Access Compliance Report Public Rights-of-Way (Curb Ramps)

Main Street: N/A Cross Street: BEACH_BLV Location: N

ADA ID: RPRK220203164443 Ramp Type: Type 7 - Directional 2 Initial Pass/Fail: Fail Overall Compliance: No Severity Score: 15

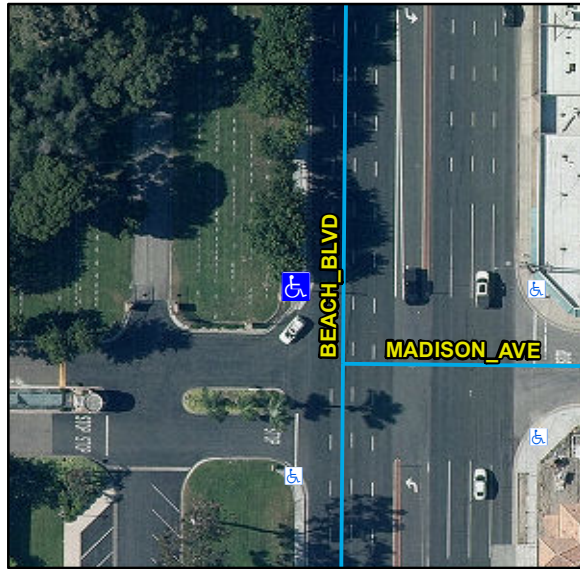
Compliance	Description	Data	Compliance	Description	Data
N/A	Ramp Length (in)	177	N/A	Flare Type LT	
Yes	Ramp Width (in)	84			N/A
No	Ramp Run Slope (%)	9.9	N/A	Flare Slope LT (%)	N/A
Yes	Ramp Cross Slope (%)	1.1	N/A	Flare Traversable LT	N/A
N/A	Grade Break	N/A	N/A	Flare Type RT	
N/A	Grade Break Slope (%)	N/A			N/A
N/A	Grade Break Cross Slope (%)	N/A	N/A	Flare Slope RT (%)	N/A
	Addl Para Ramp Left?	No	N/A	Flare Traversable RT	N/A
	Addl Para Ramp Right?	No	N/A	DWS Provided	N/A
N/A	Landing Present	N/A	N/A	DWS Contrast	N/A
N/A	Landing Length (in)	N/A	N/A	DWS Length (in)	N/A
N/A	Landing Width (in)	N/A	N/A	DWS Full Width	N/A
N/A	Landing Run Slope (%)	N/A		DWS Offset Type	N/A
N/A	Landing Cross Slope (%)	N/A	N/A	DWS Left Offset (in)	N/A
N/A	Landing Movement Obstructed?	N/A	N/A	DWS Right Offset (in)	N/A
	Landing Movement Type	N/A			
N/A	Landing Shared	N/A			
N/A	Marked Crosswalk 1	No	N/A	Clear Space	N/A
	Crossing 1 Direction	S	N/A	Clear Space To Crosswalk (in)	N/A

Marked Crosswalk 1 Width (in)	N/A			
N/A	Ramp Inside Crosswalk 1	N/A			
	Crossing 1 Slope (%)	2.9			
	Crossing 1 Cross Slope (%)	5.4			
N/A	Gutter Ponding	N/A	N/A	Curb Slope	6.8
Yes	Gutter Lip Height (in)	0		Road Run Slope (%)	N/A
N/A	Gutter Run Slope (%)	N/A		Road Cross Slope (%)	N/A
N/A	Gutter Cross Slope (%)	N/A		Parallel Ramp Side	Left
Yes	Overall Surface Condition	Acceptable	Yes	Perp Joint Present	Yes
	Cross Gutter Present?	No		Spandrel Present?	No
	Replace Cross Gutter?	N/A		Replace Spandrel?	N/A

Remove & Replace Entire Ramp.

R304.2.2, STD 1115
